UNITED STATES
NUCLEAR REGULATORY COMMISSION
WASHINGTON, D. C. 20555

Docket Nos. 50-266
and 50-301*Posted* DO NOT REMOVE
Am-9 to
APR-27

The Commission has issued the enclosed Amendments Nos. 5 and 9 to Facility Operating Licenses Nos. DPR-24 and DPR-27 for the Point Beach Nuclear Plant, Units Nos. 1 and 2. The amendments include Changes Nos. 10 and 15 to the Technical Specifications and are in accordance with your application dated July 11, 1975.

SAFETY EVALUATION BY THE OFFICE OF NUCLEAR REACTOR REGULATION
SUPPORTING AMENDMENT NOS. 5 AND 9 TO LICENSE NOS. DPR-24 AND DPR-27
(CHANGE NOS. 10 AND 15 TO THE TECHNICAL SPECIFICATIONS)

FIGURE 15-3.1-1

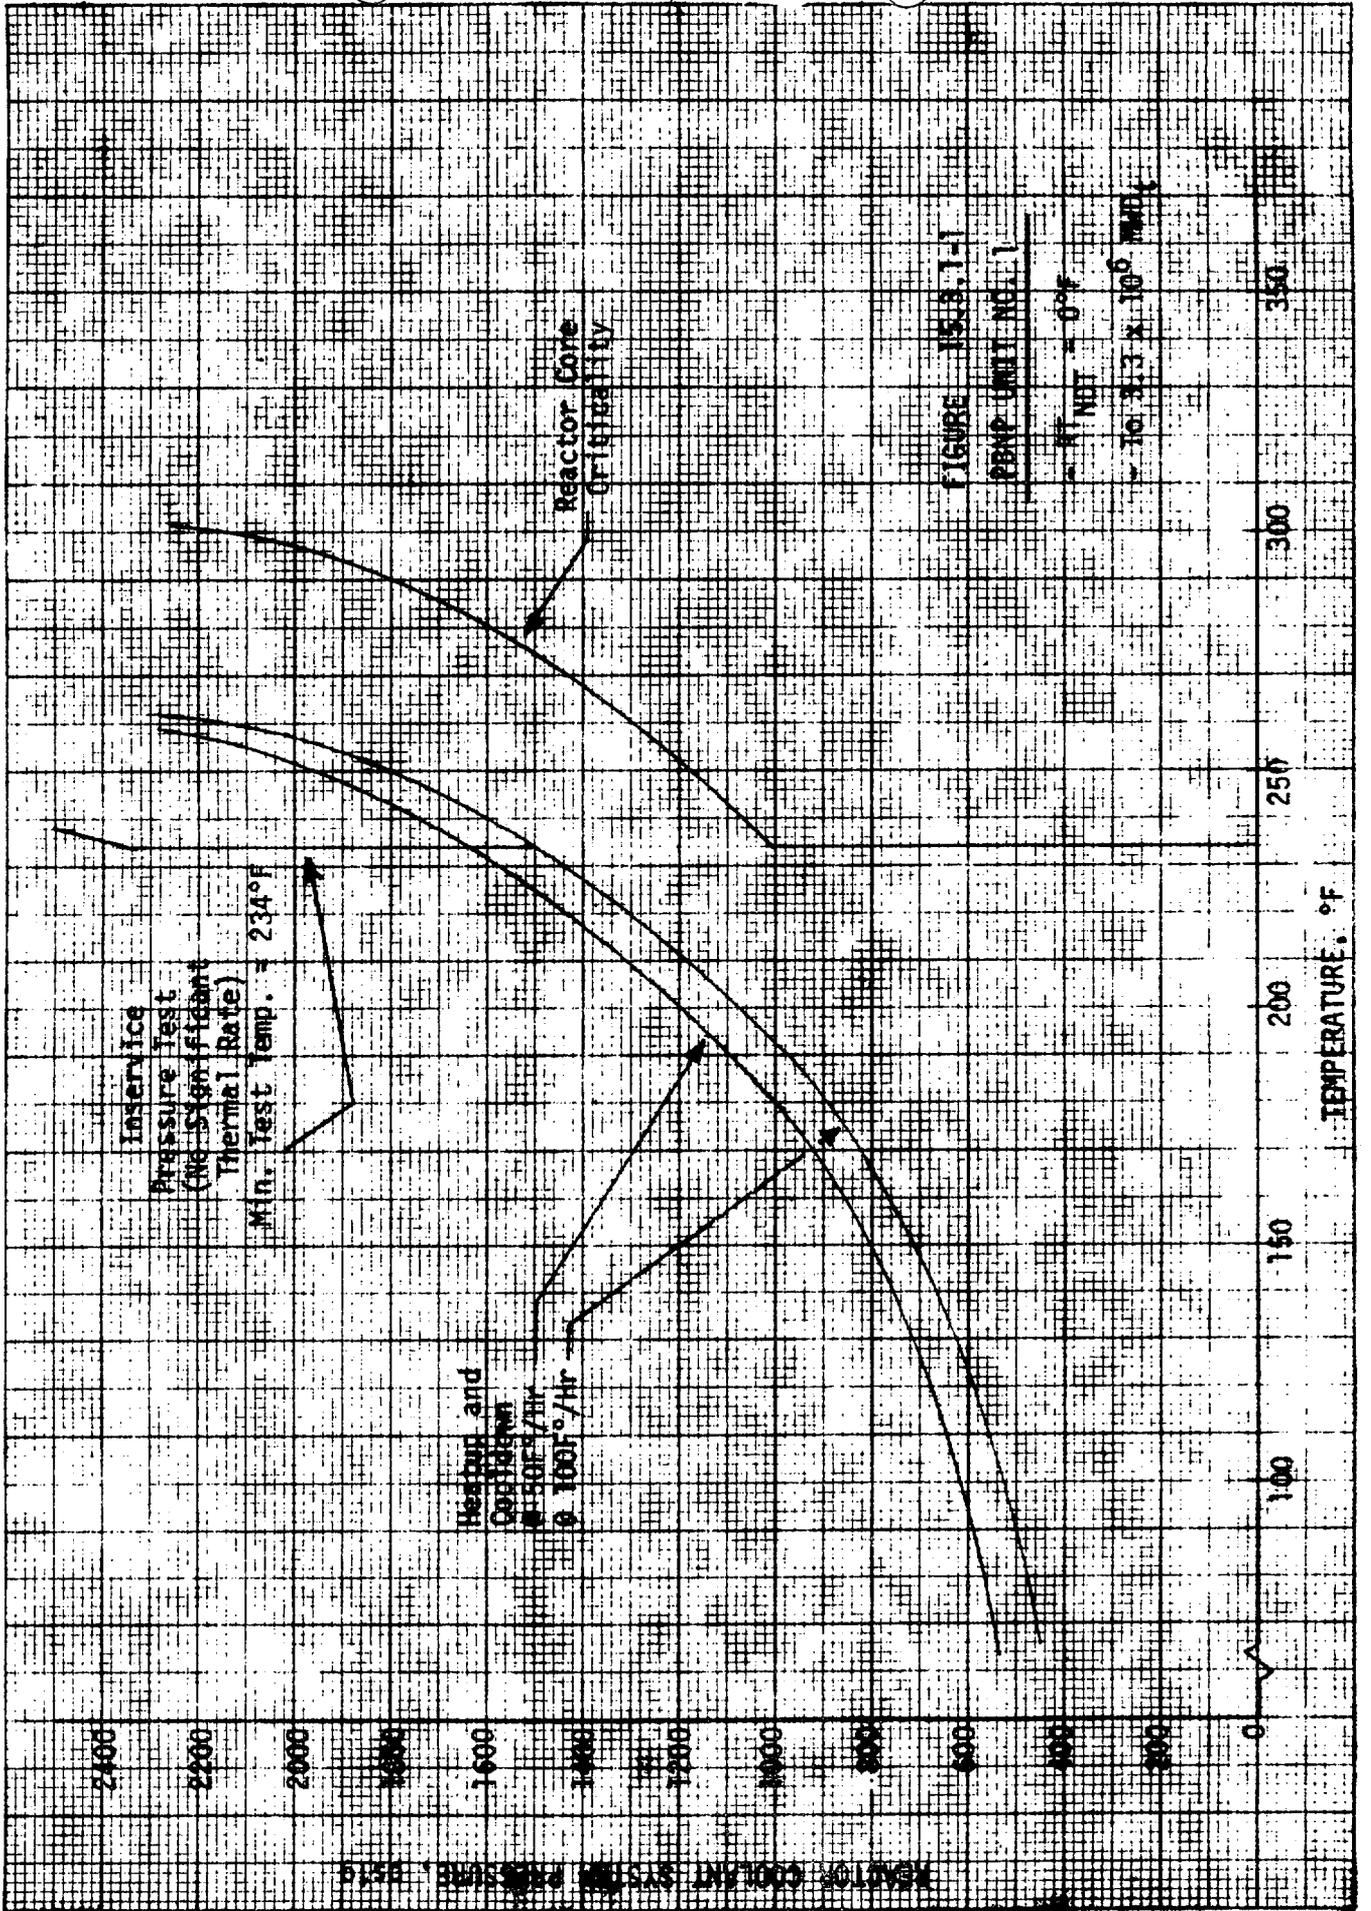
Replace pages 15.3.1-3, 15.3.1-4 through 15.3.1-8 and 15.3.1-17 and 15.3.1-18, and Figure 15.3.1-1 with the attached revised pages. (No change made on page 15.3.1-3.)

1. The Reactor Coolant System temperature and pressure shall be limited in accordance with the limit lines shown in Figure 15.3.1-1 (Unit 1) during heatup, cooldown, criticality, and inservice leak and hydrostatic testing with:

The heatup and cooldown curves presented in Figure 15.3.1-1 (Unit 1) were calculated based on the above information and the methods of ASME Code Section III (1974 Edition) Appendix G, "Protection Against Nonductile Failure" and are applicable up to the operation exposure indicated on the figures.

The pressure-temperature limits defined for hydrostatic leak tests (Figure 15.3.1-1 for Unit 1 and Figure 15.3.1-2 for Unit 2) were determined in a similar manner as the limits discussed above and in accordance with the ASME Code. In this case, however, there was no need for consideration of the thermal gradient stress intensity factor because no significant metal heatup or cooldown occurs during the hydrostatic test. We have reviewed the proposed limits and conclude that they meet the requirements of Appendix G to 10 CFR Part 50; and therefore are acceptable.

The proposed limits (Figure 15.3.1-1 for Unit 1 and Figure 15.3.1-2 for Unit 2) were derived using methods described earlier with additional safety factors required by Appendix G to 10 CFR Part 50. These additional factors include the temperature for criticality (equal to that of hydrostatic test) and an additional 40°F temperature increase beyond the operating pressure-temperature limits discussed earlier. We have reviewed the basic test data, the analytical techniques and the resultant limits and conclude that they meet the requirements of Appendix G to 10 CFR Part 50; and therefore are acceptable.

We have reviewed the reactor vessel surveillance specimen test data, the analytical techniques, and the resulting pressure-temperature curves. We have concluded that the proposed changes effectively account for shifts in RT_{NDT} , and are compatible with Appendix G to 10 CFR Part 50, and therefore, are acceptable.

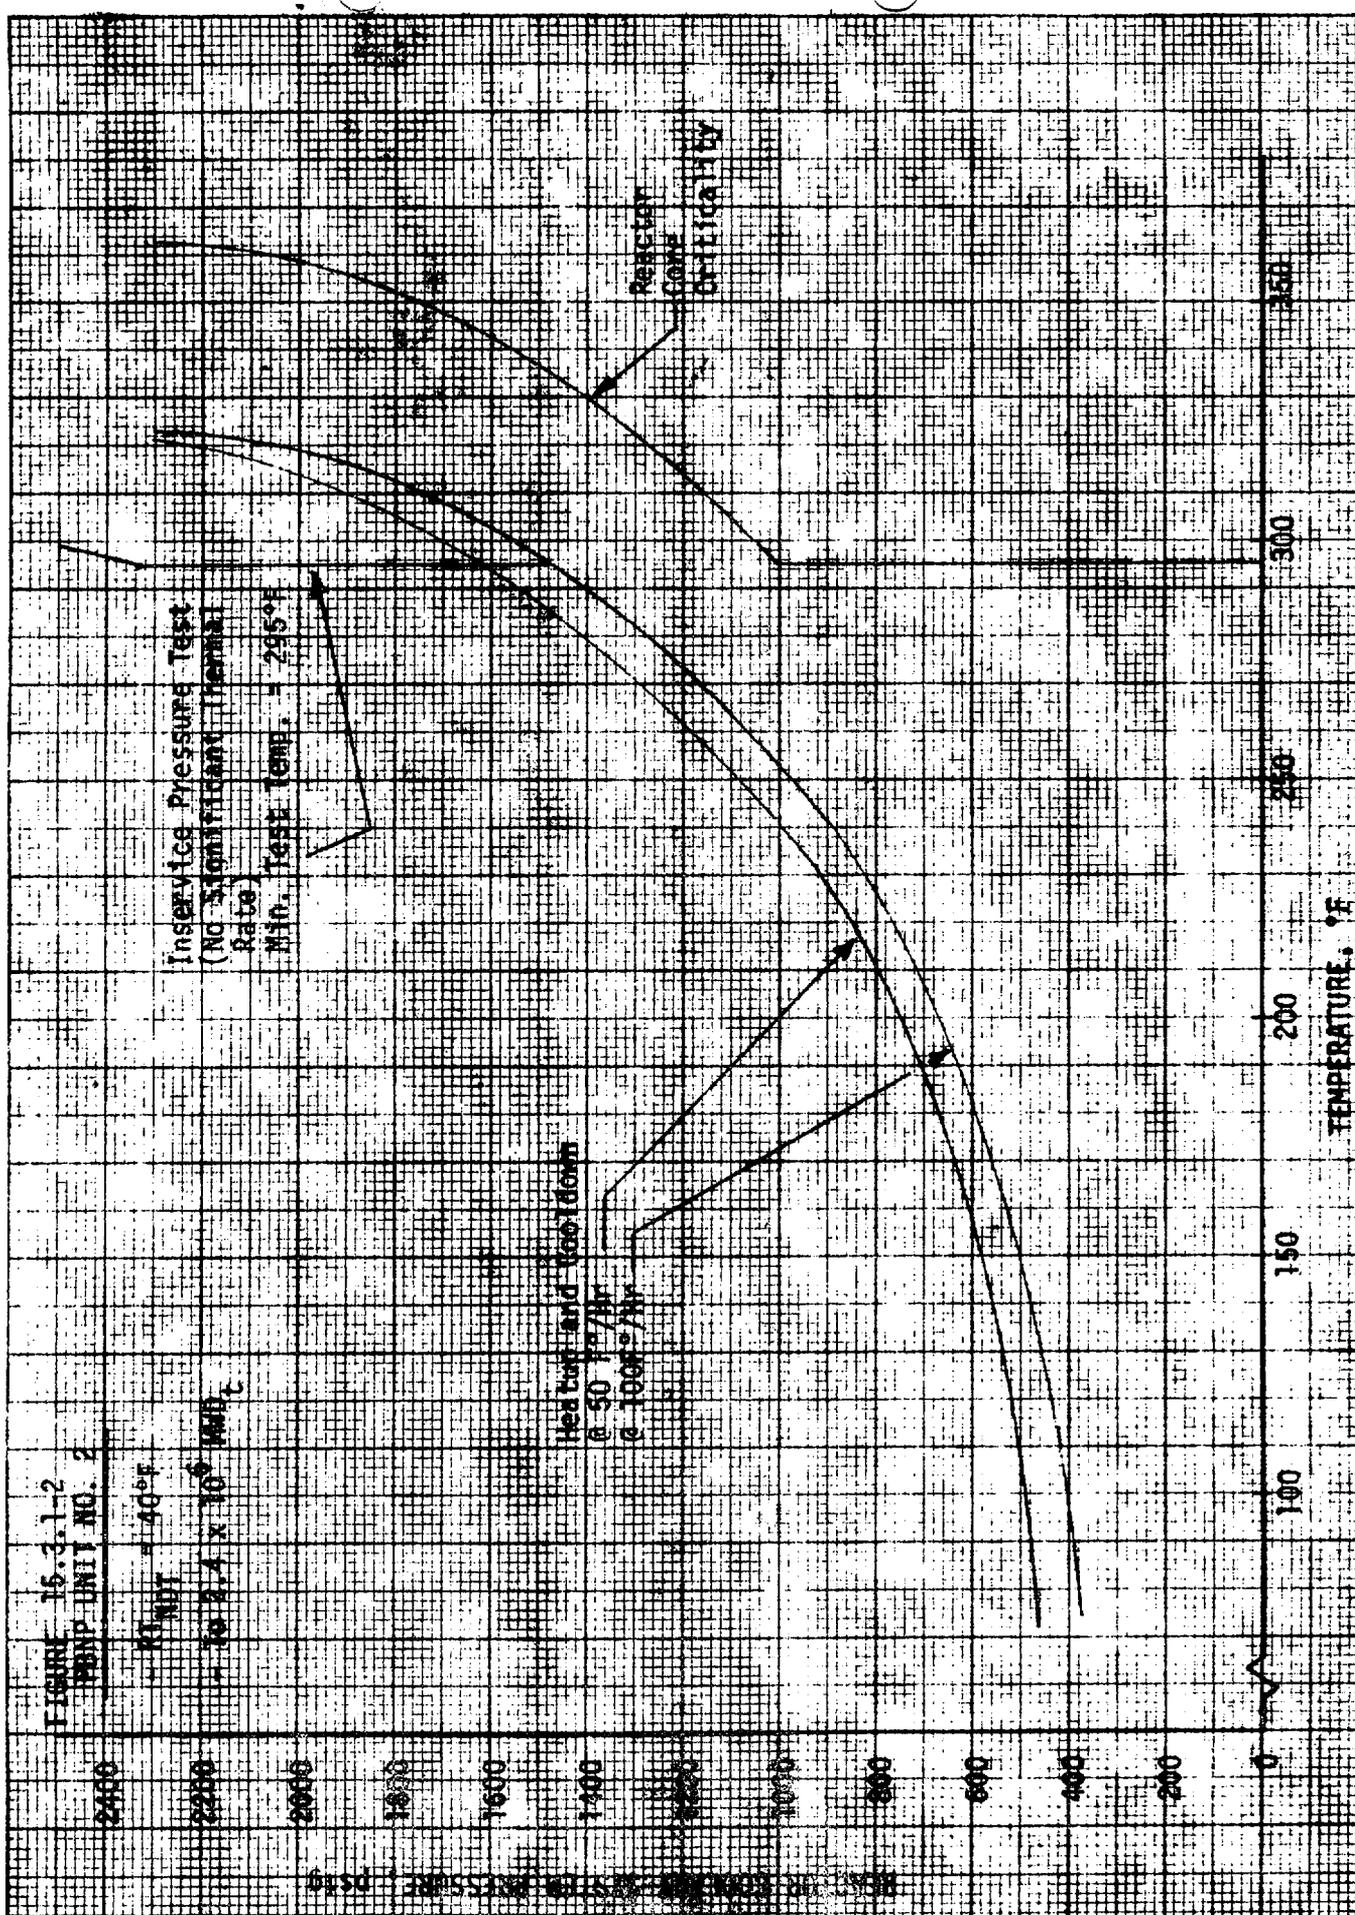
Replace pages 15.3.1-3, 15.3.1-4 through 15.3.1-8 and 15.3.1-17 and 15.3.1-18, and Figure 15.3.1-2 with the attached revised pages. (No change made on page 15.3.1-3.)

1. The Reactor Coolant System temperature and pressure shall be limited in accordance with the limit lines shown in 15.3.1-2 (Unit 2) during heatup, cooldown, criticality, and inservice leak and hydrostatic testing with:

The heatup and cooldown curves presented in Figure 15.3.1-2 (Unit 2) were calculated based on the above information and the methods of ASME Code Section III (1974 Edition) Appendix G, "Protection Against Nonductile Failure" and are applicable up to the operation exposure indicated on the figures.
